**Project #19-030  
Logan Riverwalk Commercial Building  
Locate at 80 East 400 South**

*Project Name:* Logan Riverwalk Commercial Building  
*Proponent / Owner:* Bracken Atkinson  
*Project Address:* 80 East 400 South  
*Request:* Design Review  
*Current Zoning:* Commercial (COM) & Mixed Use (MU)  
*Type of Action:* Quasi-Judicial  
*Hearing Date:* August 22, 2019  
*Submitted By:* Russ Holley, Senior Planner

C-101

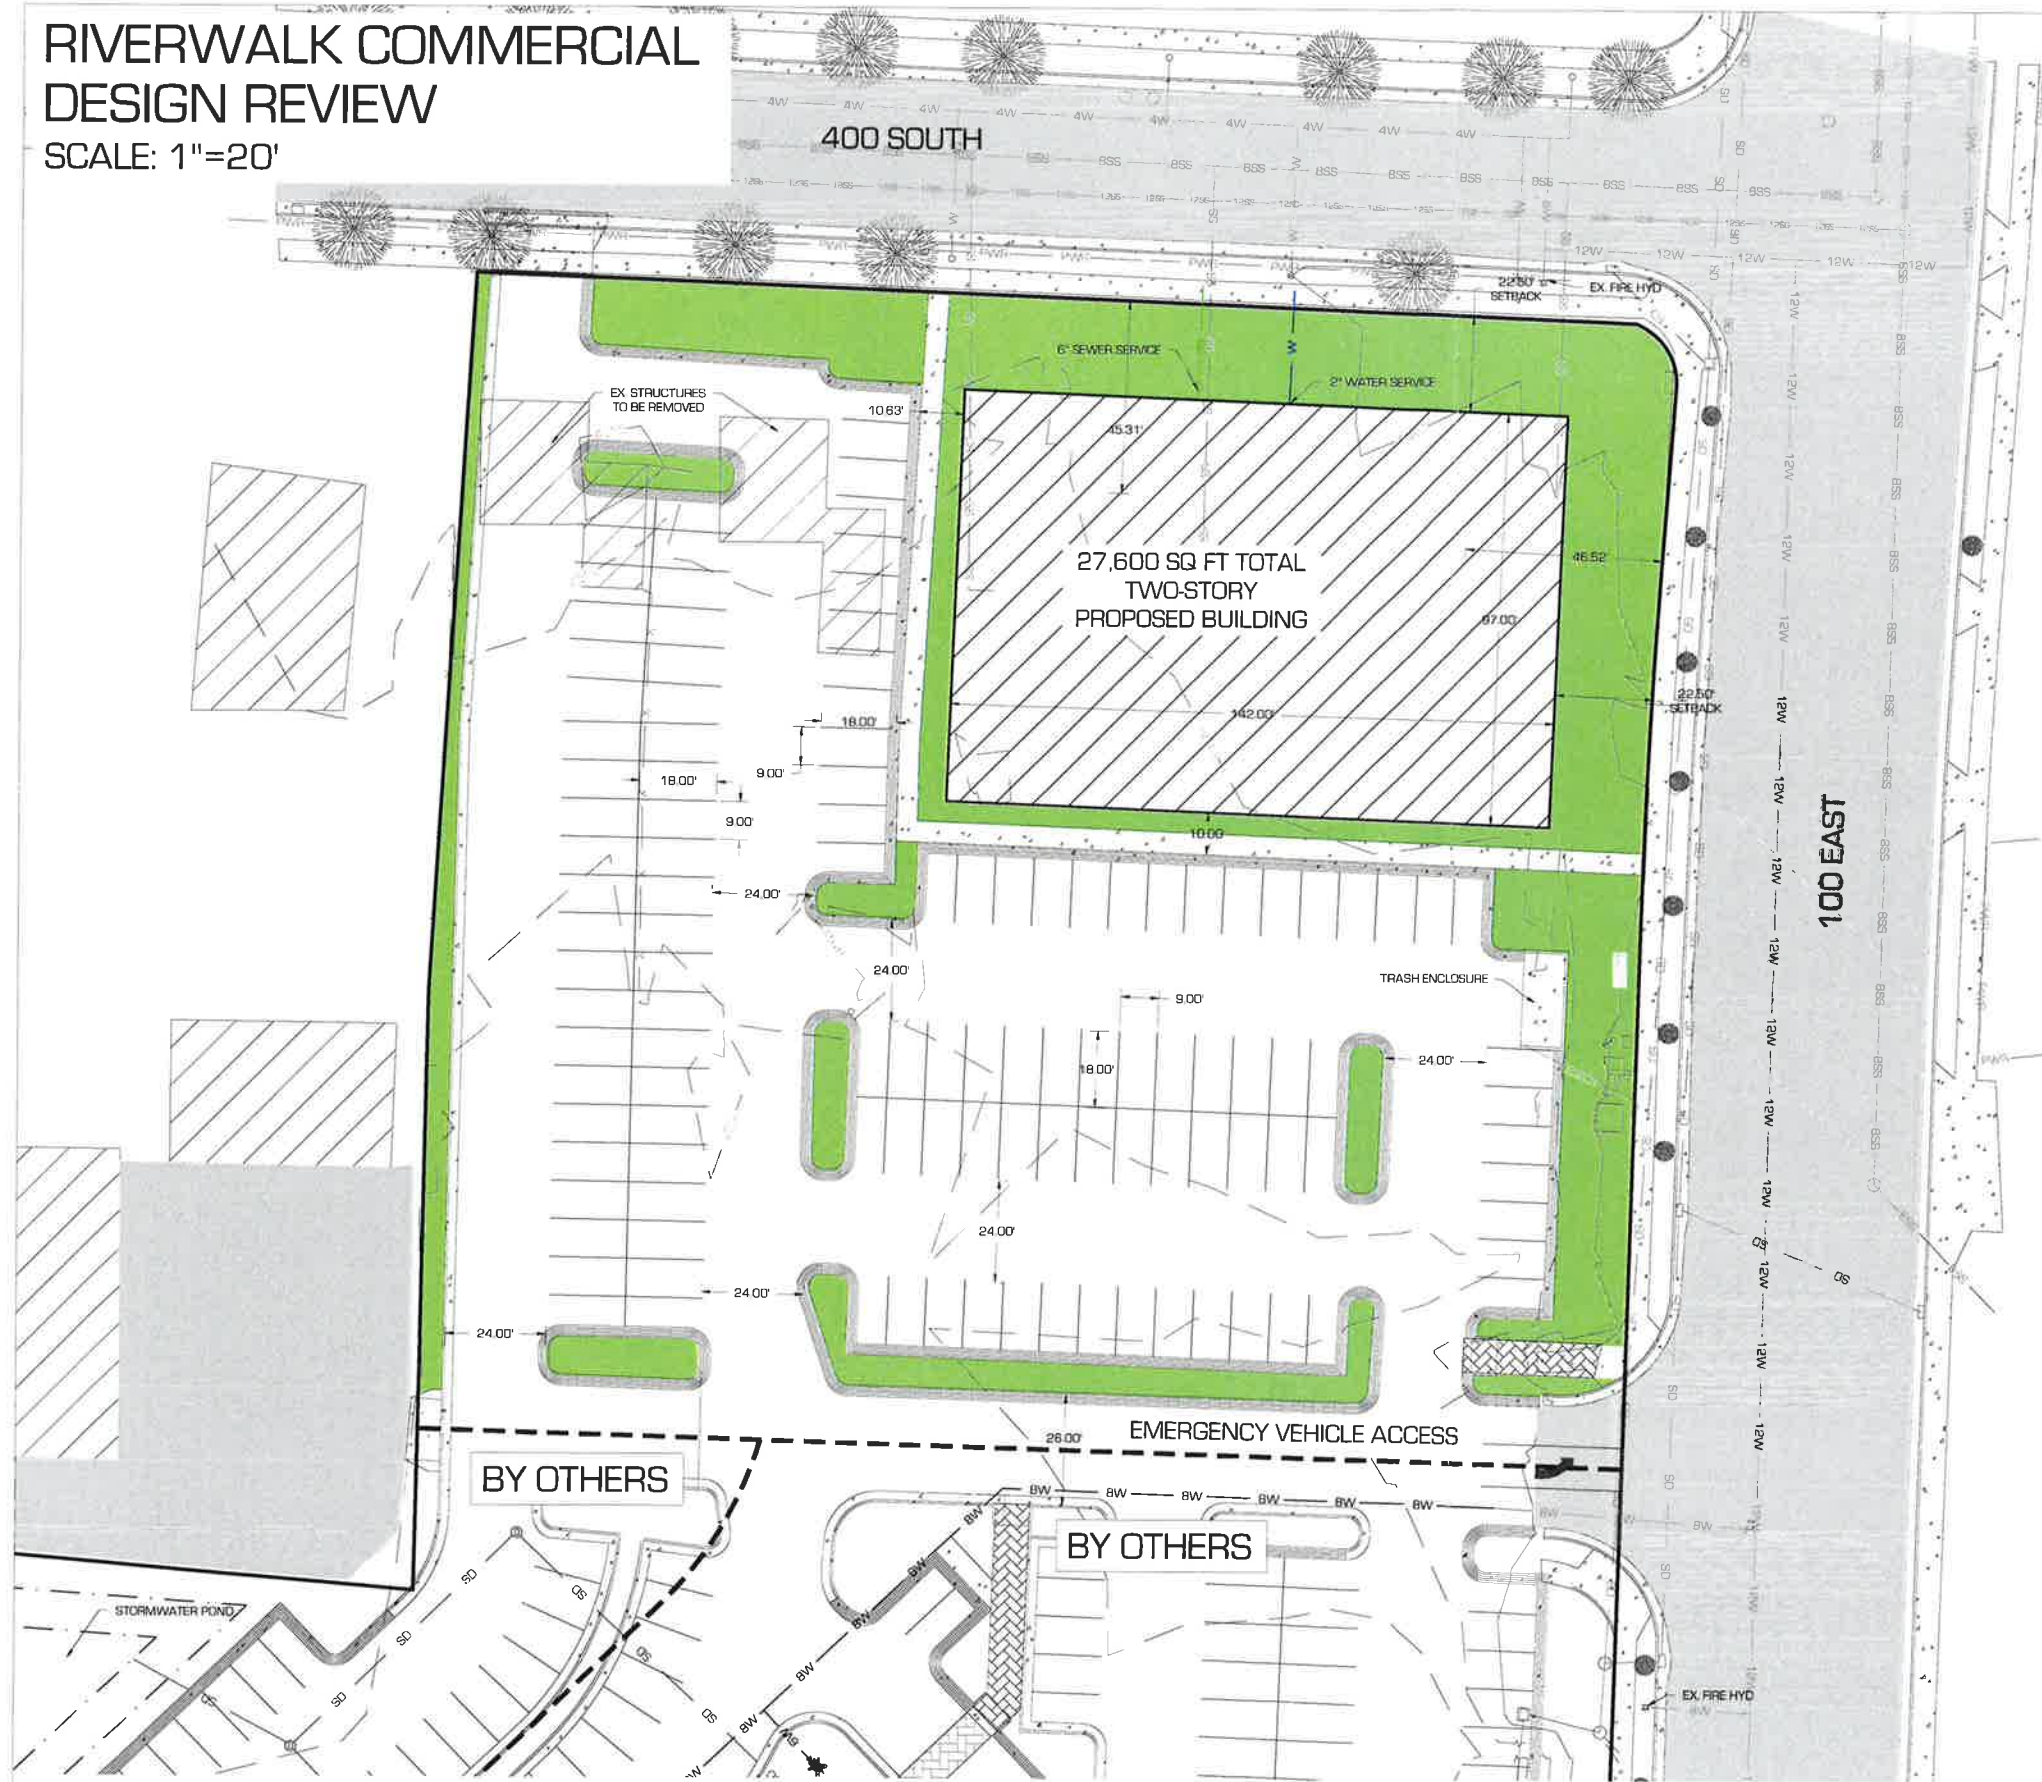
As conditioned with the enhanced front and corner setbacks of 25’ and 20’ in areas adjacent to NR zoning, the project complies with the requirements in the LDC.

The proposed building meets minimum transparency requirements in the LDC. The rear façade adjacent to the parking lot has an entry feature with an additional significant amount of glass creating a building design that is not considered 4-sided architecture. As conditioned with architectural features and transparency levels similar on all 4-sides, the project complies with the requirements in the LDC.

The LDC allows for buildings to have primary entrances not oriented towards the street if the building façade facing the street has similar architectural features and as the primary entrance/façade. The commercial building has an entry on the front façade adjacent to 400 South street but does not contain similar architectural features found on the rear façade facing the parking lot. As conditioned with similar entryway architectural features in the front and back, the project complies with the requirements in the LDC.

For an office, the LDC 17.31 requires vehicular parking at one (1) parking stall per every 300 SF of office space. At approximately 35,000 SF of office space, 116 parking stalls would be required. As proposed, 120 parking stalls are provided meeting LDC requirements. The LDC requires bike racks in commercial areas. As conditioned with minimum parking stalls and a bike rack, the project complies with the requirements in the LDC.

3. The front yard building setback (north) shall be 25' and the corner yard building setback (east) shall be 20' to match the NR zones across the streets.

4. The building shall have 4-sided architecture with rear façade architectural features matching front facades. All entryways shall have minimum weather protections and features that emphasis inviting entrances.

5. All frontage and exposed ground floor sides shall meet 30% transparency requirement.
6. A minimum of 116 parking stalls shall be provided for the office at a ratio of one (1) parking stall per every 300 SF of office space. A bike rack shall be installed on-site for bike parking.

7. Parking for the commercial buildings will be located in the side or rear yard.
8. A minimum parking setback of 10' along 400 S is required. A dense landscaping buffer will be constructed between the parking and the sidewalk along 400 S and 100 E. The buffer shall conform with Type "C" Separation LDC 17.32.070.B.
